Evaluation of Physical Barriers – North Main Corona

Address: East Blaine St, Corona, CA 92880

Evaluation Date: 07-21-2021

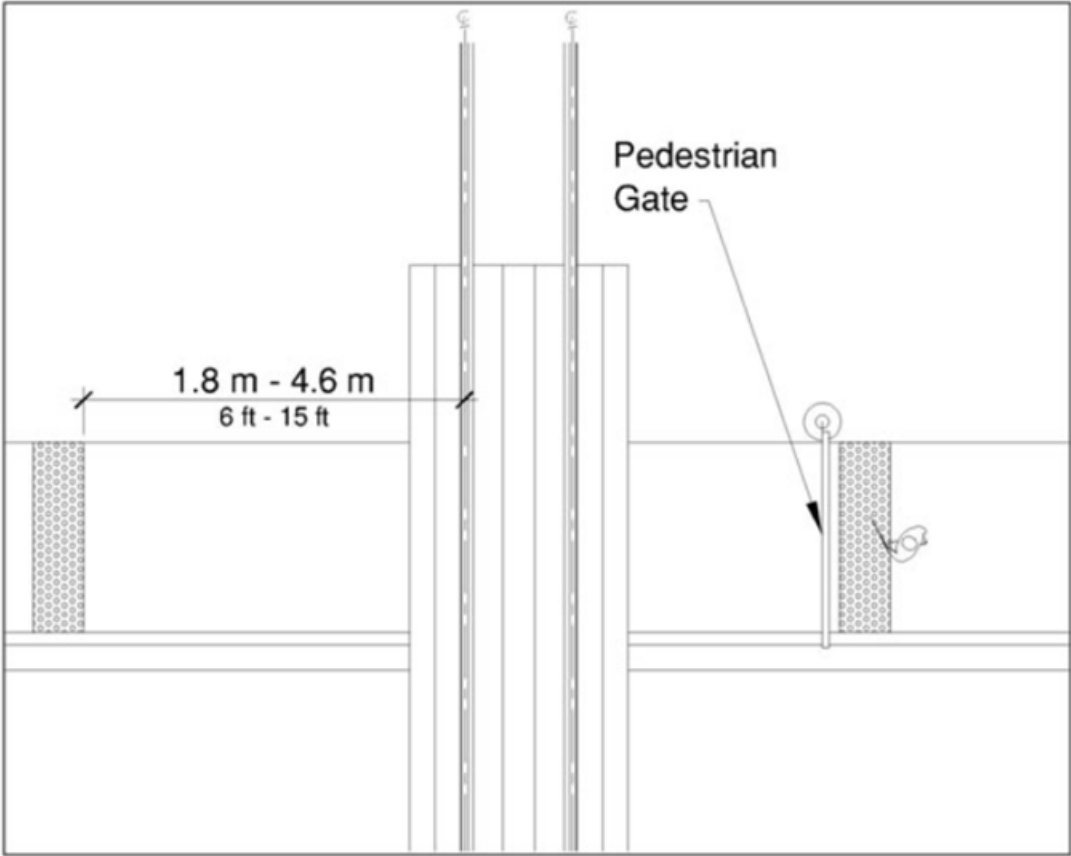
Issues/ Barriers Identified	Recommendations	Comments/ ADA Requirements
1. Curb Ramps		
1a, 1b- OK 2a - OK 2b, 2c- Not an accessible route due to curved ramps. Gate remains closed. 3a, 3b Not a required accessible route. 3a Landing is less than 36 inches. 4a, 4b- Cross slope of ramps exceeds 2 % 5a, 5c- Not a required accessible route. 5b - OK 6a Not an accessible route due to barrier arm in closed position blocking access to/from the city sidewalk. 6b- Ramp is not compliant due to uneven pavement, level changes in excess of ¼” and excessive slope. 7a, 7b- OK, but not a required accessible route. 8a – Slope of flared side of the curb ramp is more than 1:10. Curb ramp is not in RCTC’s scope.	3a- When used for providing access in the future, the landing shall be increased to be at least 48 inches deep and it shall join an accessible route. 4a, 4b. Repair cross slope. 6b. Remove the trip hazard and provide flush transitions adjacent to curb ramps if this is a designated marked crossing. See item 2. Provide signage designating the accessible pedestrian entry.	This evaluation does not include curb ramps outside the RCTC boundary. RCTC is not responsible for maintaining the accessible routes outside of RCTC boundary. When repairs begin, use proper and precise instruments (4-foot smart level and 2-foot smart level) to fit within the curb ramp width and the adjacent gutter to measure ramp slopes, cross slopes, and counter slopes at all curb ramps (all stations). The long slope of ramp shall not exceed 1:12 (8.33%). Slope of flared sides shall not exceed 1:10 (10%), the gutter slope shall not exceed 1:20 (5%). Cross slope of the ramp and landing shall not exceed 1:50 (2%) Use smart level instruments, calibrated in accordance with manufacturer’s instructions before taking measurements.

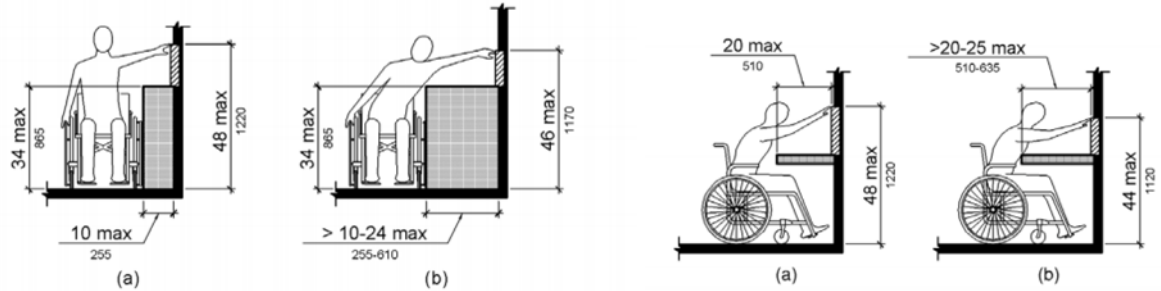
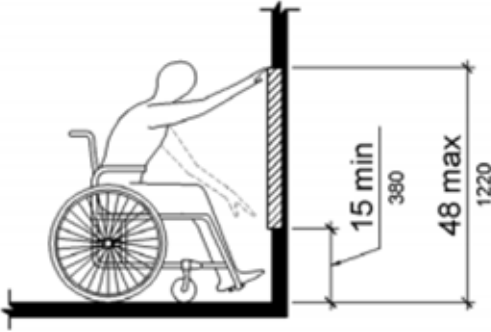
a) Pedestrian Push Button- Not Applicable	No action by RCTC	
3. Accessible Routes		
a) Walking surface		
i. General: Repair accessible route where there are uneven joints and cracks observed in old and new concrete along the accessible route, and sealant/filler in some deep joints is missing. This causes trip hazards and creates openings deeper than 1/4" and wider than 1/2 inch.	<p>Every joint in concrete deeper than 1/4" and wider than 1/2" shall be filled.</p> <p>Every level change along the accessible route greater than 1/4" and less than 1/2" height needs to be beveled (1:2) slope or repaired.</p> <p>Every level change greater than 1/2" needs to have a ramped surface (1:12) slope.</p>	<p>Figure 302.3 Elongated Openings in Floor or Ground Surfaces</p> <p>Figure 303.2 Vertical Change in Level</p> <p>Figure 303.3 Beveled Change in Level</p>
ii. Cross slope of sidewalks and pedestrian crossings on the accessible routes exceeds 2% in some instances	Measure cross slopes along the accessible route and repair excessive deviations.	403.3 Slope: The running slope of walking surfaces shall not be steeper than 1:20. The cross slope of walking surfaces shall not be steeper than 1:48.

Issues/ Barriers Identified		Recommendations	Comments/ ADA Requirements
<p>iii. Width of accessible route on the ground level (sidewalk) from the garage exit gate going towards the elevators/pedestrian crossing narrows down to 28 inches along the structural columns and bollards. This sidewalk does not meet accessibility requirements for minimum width of 48 inches.</p> <div></div>		Provide signage at the gate identifying the alternate accessible route.	
<p>iv. Curved ramps leading to the garage at 2b are not accessible due to the cross slope exceeding ADA requirements of minimum 2%</p> <div></div>		Provide signage pointing to the accessible route. Remove signage identifying the curved ramps as accessible routes.	Advisory 405.7 Landings. Ramps that do not have level landings at changes in direction can create a compound slope that will not meet the requirements of this document. Circular or curved ramps continually change direction. Curvilinear ramps with small radii also can create compound cross slopes and cannot, by their nature, meet the requirements for accessible routes.
